E4418B-16

S E R V I C E N O T E

Agilent E4418B EPM Average Power Meter

Front Panel Dimension Might Not Be Suitable For Rack Mounting Solutions

Figure 1

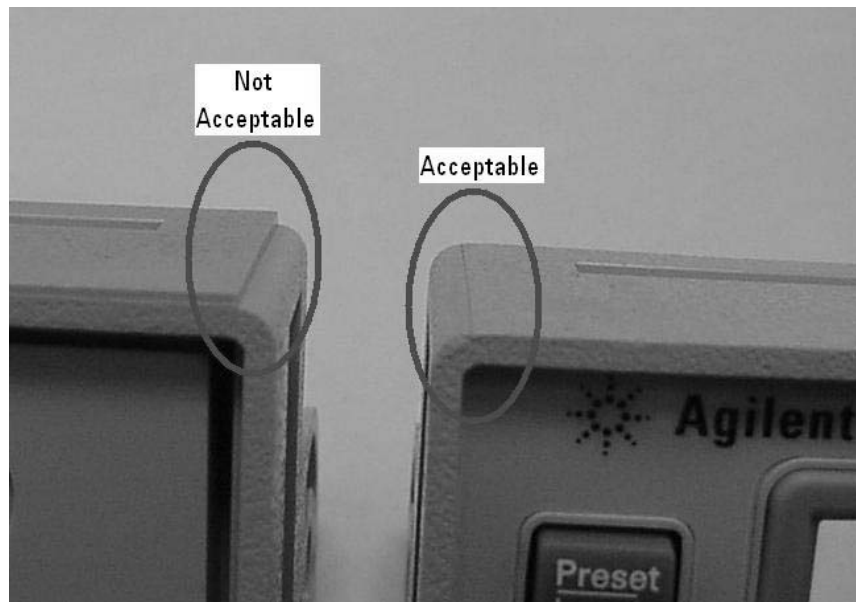
A tooling issue has resulted in some E4418B power meters being shipped with excess material on the top edge of the Front Panel Assembly. The height of this excess material varies, but it has been noted that when it exceeds 0.5mm the meter may no longer be suitable for rack mounting solutions.

Figure 1 shows the physical difference between an acceptable and an unacceptable Front Panel Assembly.

If the height of the excess material is 0.5mm (or less), then no further action is necessary.

If the height of the material exceeds 0.5mm, then the Front Panel Sub-assembly must be replaced (refer to Service Note E4418B-14 for instructions on how to remove & replace the Front Panel Sub-Assembly).
